TSG-RAN Meeting #13
Beijing, China, 18 - 21, September, 2001

TSGRP#13(01) 0576

Title: Agreed CRs to TS 25.402

Title:	⌘ Notation of Time Instances		
Source:	⌘ R-WG3		
Work item code:	⌘ TEI	Date:	⌘ 2001-08
Category:	⌘ F	Release:	⌘ R99
	Use <u>one</u> of the following categories:		Use <u>one</u> of the following releases:
	F (correction)		2 (GSM Phase 2)
	A (corresponds to a correction in an earlier release)		R96 (Release 1996)
	B (addition of feature),		R97 (Release 1997)
	C (functional modification of feature)		R98 (Release 1998)
	D (editorial modification)		R99 (Release 1999)
	Detailed explanations of the above categories can be found in 3GPP TR 21.900 .		REL-4 (Release 4)
			REL-5 (Release 5)

Figure 2: Timing of UTRAN counters

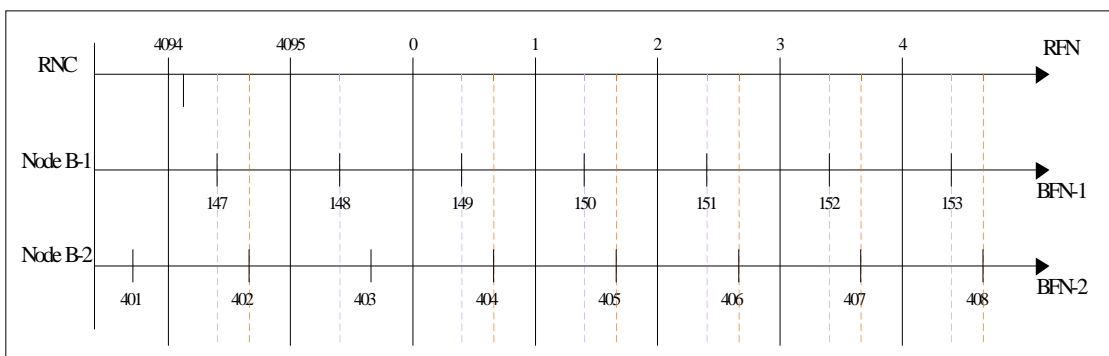
Reason for change:	⌘ At RAN WG3 meeting nr22, there was a decision on an uniform notation for time instances: Capital letters are to be used for this purpose. (This decision was made in lub/lur SWG at agenda item rb-2.5.3, when TDoc R3-012055 on TS25.435 was discussed). This CR provides the corresponding changes for TS25.402. In addition, an outdated "FFS" statement now removed.
Summary of change:	⌘ 1) General alignment of notation: Capital letters 2) Removal of outdated "(FFS)" statement in section 4.3 3) Correction of typo in 8.3.4.4.2
Consequences if not approved:	⌘ Inconsistent notations between and inside RAN3 specifications. <u>Backwards compatibility:</u> Protocols are not affected at all, thus this change is backwards compatible. <u>Isolated impact:</u> Functions of UTRAN entities not affected, thus isolated impact is given.

By Node Synchronisation it's generally meant the achievement of a common timing reference among different nodes. In UTRAN although a common timing reference among all the nodes could be useful, it is not required. In fact different nodes' counters (RFN and BFN), even if frequency-locked to the same network synchronisation reference, may be not phased aligned (see Figure 2).

Figure 2: Timing of UTRAN counters

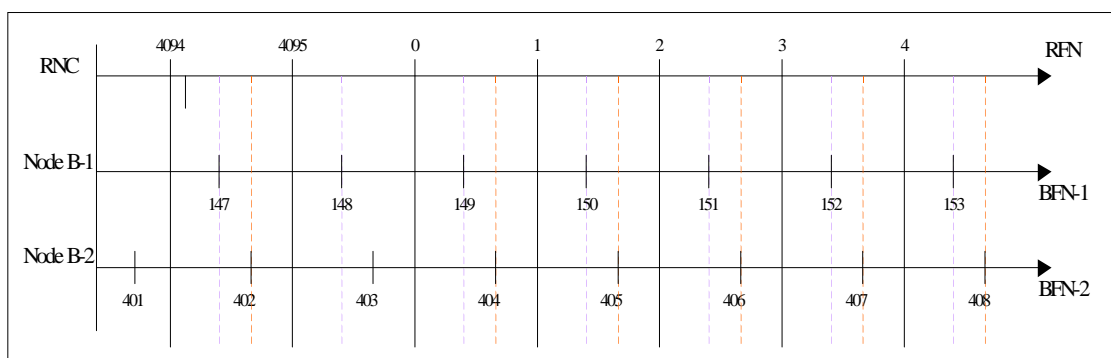
Reason for change:	⌘ This CR is a mirror for REL-4 from CR026 for R99.
	Background: At RAN WG3 meeting nr22, there was a decision on an uniform notation for time instances: Capital letters are to be used for this purpose. (This decision was made in lub/lur SWG at agenda item rb-2.5.3, when TDoc R3-012055 on TS25.435 was discussed). This CR provides the corresponding changes for TS25.402, REL-4 In addition, an outdated "FFS" statement now removed.
Summary of change:	⌘ <ol style="list-style-type: none">1) General alignment of notation: Capital letters2) Removal of outdated "(FFS)" statement in section 4.33) Correction of typo in 8.3.4.4.2
Consequences if not approved:	⌘ Inconsistent notations between and inside RAN3 specifications. <u>Backwards compatibility:</u> Protocols are not affected at all, thus this change is backwards compatible. <u>Isolated impact:</u> Functions of UTRAN entities not affected, thus isolated impact is given.

By Node Synchronisation it's generally meant the achievement of a common timing reference among different nodes. In UTRAN although a common timing reference among all the nodes could be useful, it is not required. In fact different nodes' counters (RFN and BFN), even if frequency-locked to the same network synchronisation reference, may be not phased aligned (see Figure 2).
